FMM230 Product Change Notifications

[Main Page](#) > [Advanced Trackers](#) > [FMM230](#) > **FMM230 Product Change Notifications**

2023.12.13: Certification Engraving Update

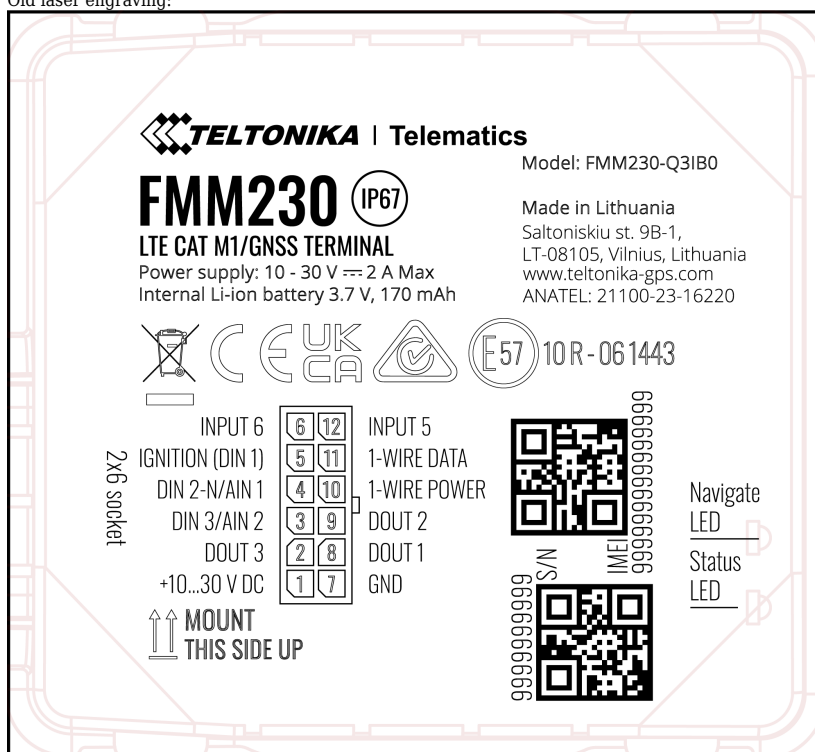
Change type	Internal
Detailed description	The specifications of laser engraving devices have undergone modifications subsequent to their certification by Anatel and Bluetooth® SIG, ensuring compliance with rigorous standards. These changes affect FMM130-QG5 and FMM230-Q3IB0 devices. Old laser engraving:

Change reasons	The devices have received approval from both Anatel certification and compliance with the Bluetooth® SIG standard. These changes affect FMM130-QG5 and FMM230-Q3IB0 devices.
Release date	December, 2023

Model	Affected order codes	Order code changes
FMM230	FMM230-Q3IB0	Updated laser engraving.
